**Monks Orchard Residents' Association  
Planning**

**Location:** 67 Orchard Avenue, Croydon, CR0 7NE,

**Application Number:** 20/01997/FUL

**Appeal ref:** APP/L5240/W/20/3260388

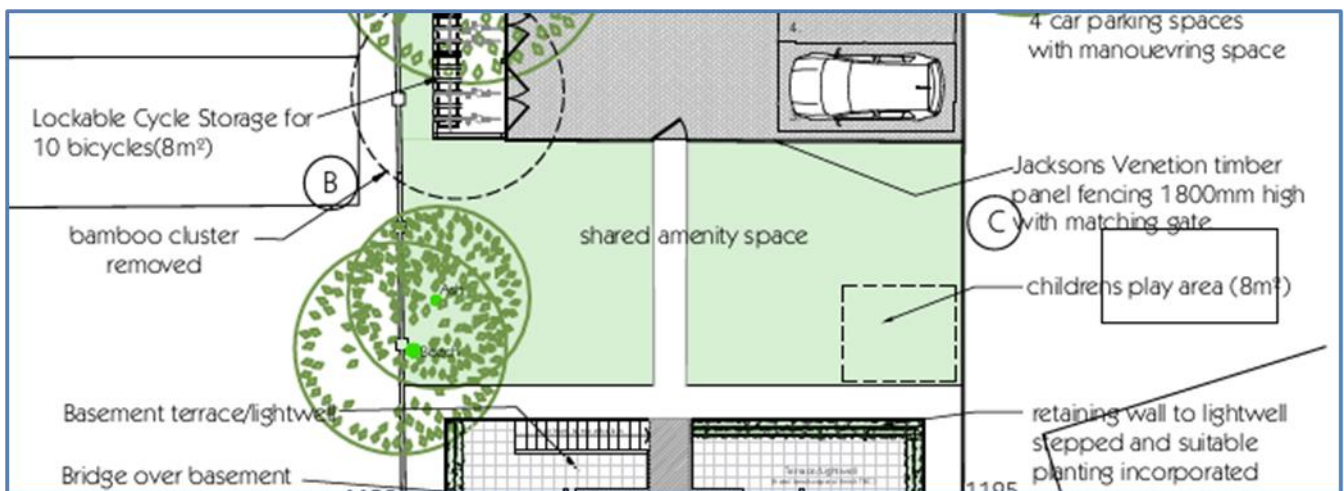
The Policy does NOT define an allocation of 'Communal Open Space' per occupant of a multi-occupation dwelling – *which is a deficiency of the policy definition*. However, the area of shared amenity space once the 8m<sup>2</sup> play space for children is deducted does NOT seem to be adequate for 12 (probable) adults. As the policy does not specify an allocation per resident, the assessment is a subjectively determined by the case officer. *It is difficult to challenge the provision if the policy is an undefined objective.*

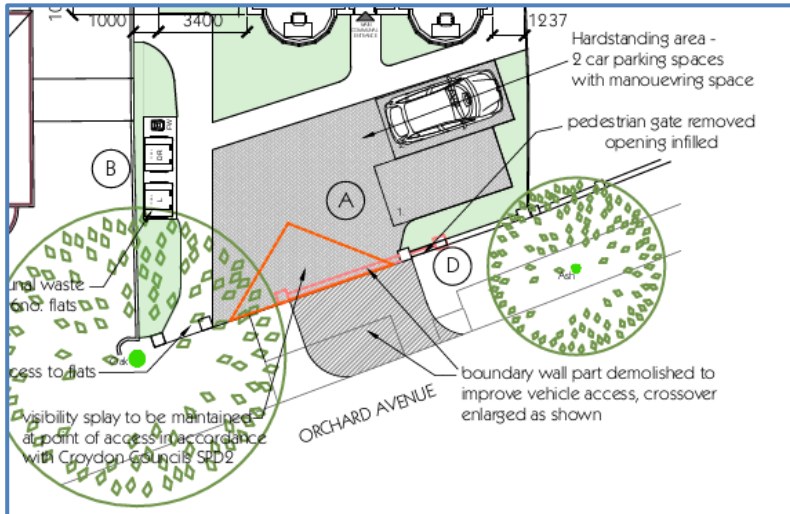
**The Plans show Vehicular access from Orchard Avenue – which is a very busy feeder road between the A232 (Wickham Road) to the south and the A222 (Long Lane) to the North.**

The entrance to 67 Orchard Avenue shows a preferred entrance from the off-side of Orchard Avenue (from the North) which requires crossing the line of traffic from the South in order to enter the site.

The entrance from the nearside (travelling from the south to north) crossover configuration would require a significant left-hand lock of steering to negotiate the anti-curvature of the access across the footpath which would dissuade drivers from entering from this south to north direction. Entry is preferred from the north-to-south carriageway crossing the south-to-north traffic.

Once entered, it is unclear whether access to a vacant parking space

would be possible in a single manoeuvre. It would be helpful if the applicant had provided swept path diagrams to show ingress and egress from both parking bays if the other bay was occupied. It is doubtful whether it would be possible to exit in a forward gear once parked in a forward direction without extensive unacceptable backward and forward manoeuvres.

Also, when exiting, the 'Crossover' configuration guides the driver to join the north bound direction carriageway direction of travel, rather than allow, a difficult manoeuvre, to cross the nearside line of north bound traffic to travel south. This may be a design feature for safety but could be very inconvenient for the driver who may want to travel in the opposite direction to that being forced by the access drive configuration.

Access to and from parking spaces to the west of the development with access from/to Woodland Way are likely to be less difficult with the added advantage of a less busy suburban road with no through access resulting in much less traffic.

Basement Floor Plan

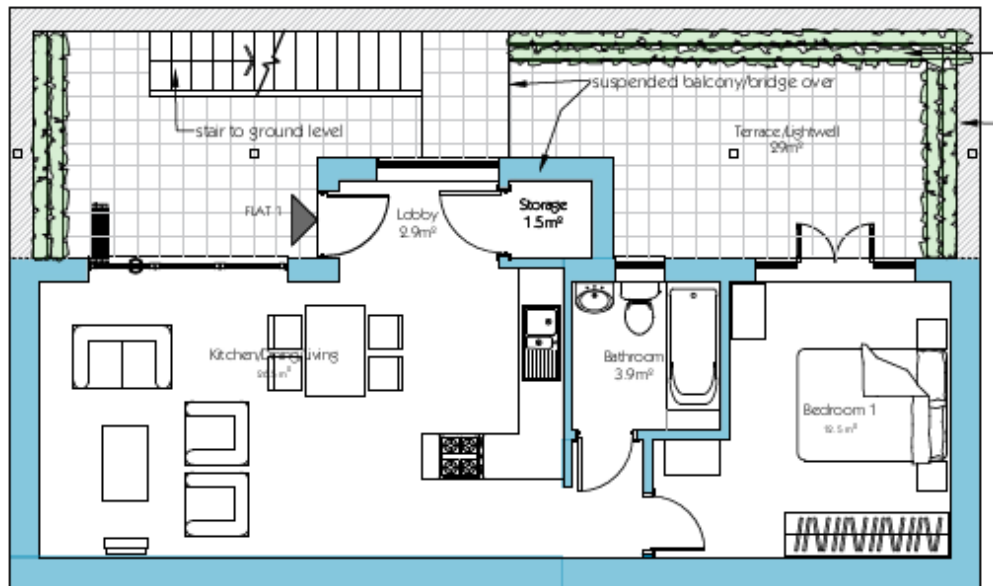
**Considering this proposed development will be available for accommodation well into the 21<sup>st</sup> century, with the threat of climate change and increases in precipitation and potential flooding, it would be inappropriate for approval of basement accommodation this close to an area of potential flooding, especially with sleeping quarters below ground level. A ‘flash flood’ during the night could have disastrous consequences.**

**Squeezing as much accommodation as possible into a site area, including an unnecessary basement accommodation, when such is not recommended so close to an area subject to flooding, should be challenged and probably refused on those grounds. Basement accommodation is unnecessary in these suburban localities and in such areas subject to underground streams such as 'The Chaffinch Brook'.**

**Graphical Representation of the calculations above**

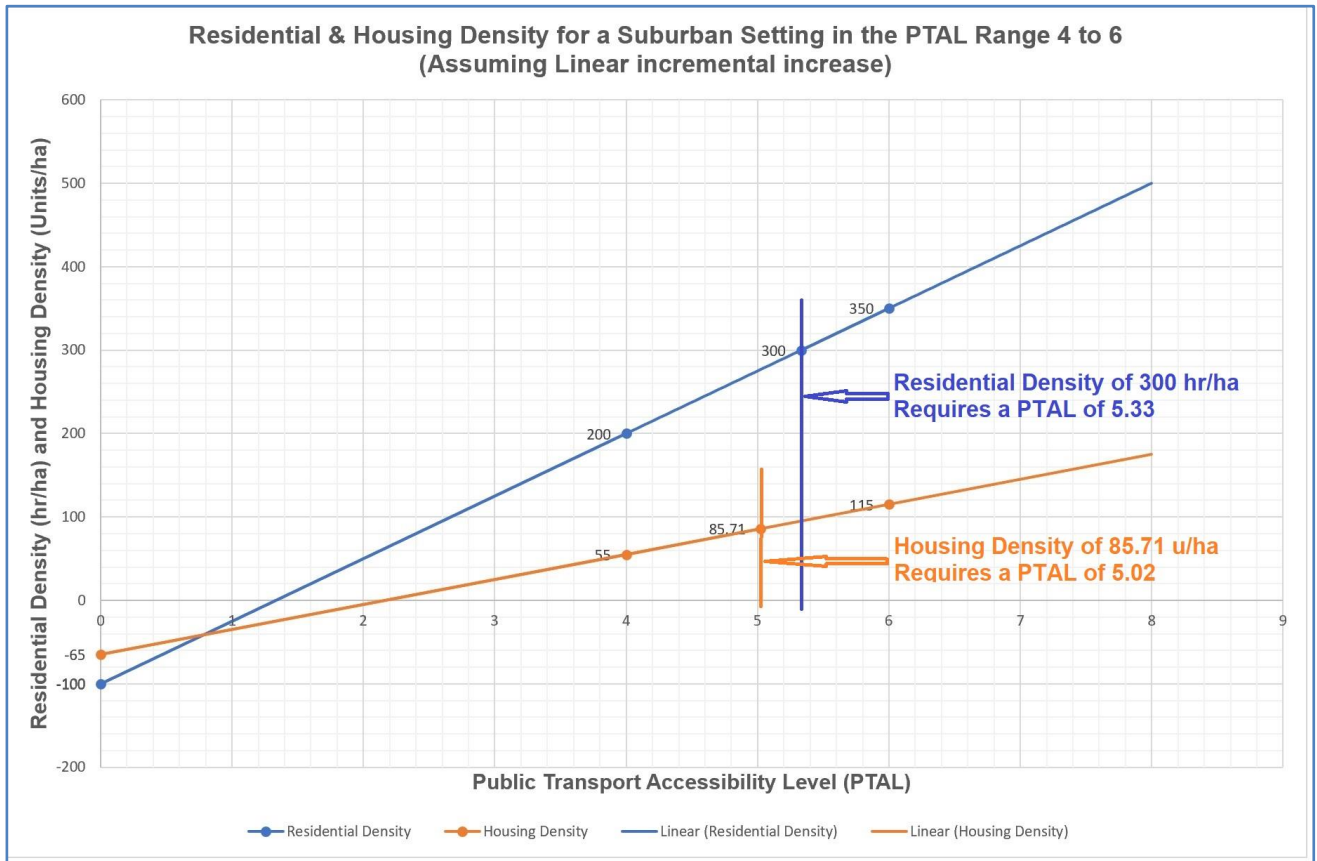
$$y = 85.71 = 30x + (-65) :: 150.71 = 30x \quad \text{therefore } x = \text{PTAL} = 5.02$$

The applicant has not provided any justification for not meeting the guidance of Table 3.2.
